**HISTORIC PRESERVATION REVIEW BOARD  
STAFF REPORT AND RECOMMENDATION**

Landmark/District: **Anacostia Historic District** (x) Agenda  
Address: **2100 Martin Luther King Jr. Avenue SE**

Meeting Date: **January 28, 2016** (x) New construction  
Case Number: **16-156** (x) Subdivision

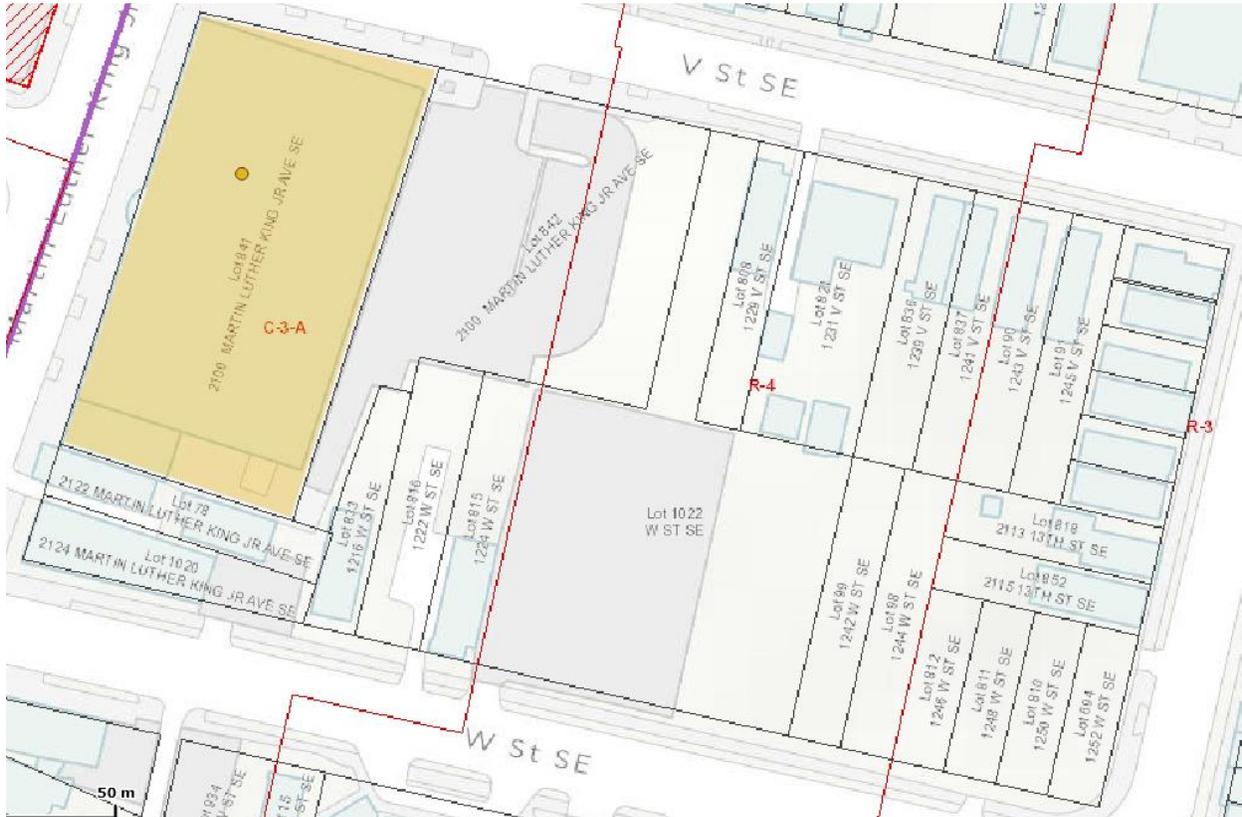
On its east elevation, the building has projecting pavilions of brick, with the recesses between in a secondary, cementitious material. The façade's brick pavilion is its focal point, but the expanse of the secondary material makes it a competing primary material. It should not be. There is a generally understood hierarchy of materials based on their historic usage and cost, as well as on their relative weight, real or apparent. Even if a panel is cementitious and heavy, it is understood to be lighter than true masonry, because it is thin and hung off the framing.

The primary and base building material should be the brick, with the panelized material employed as secondary, especially on a piece such as the fifth floor, which should read as a penthouse or attic, separate from the main block below. The reverse, setting a brick penthouse in the middle of a roof atop a panelized frame story, is less convincing. Removing the cementitious panels from the façade also avoids their awkward return around the west side in a manner that reads like an oversized bay, distinct from the building behind.
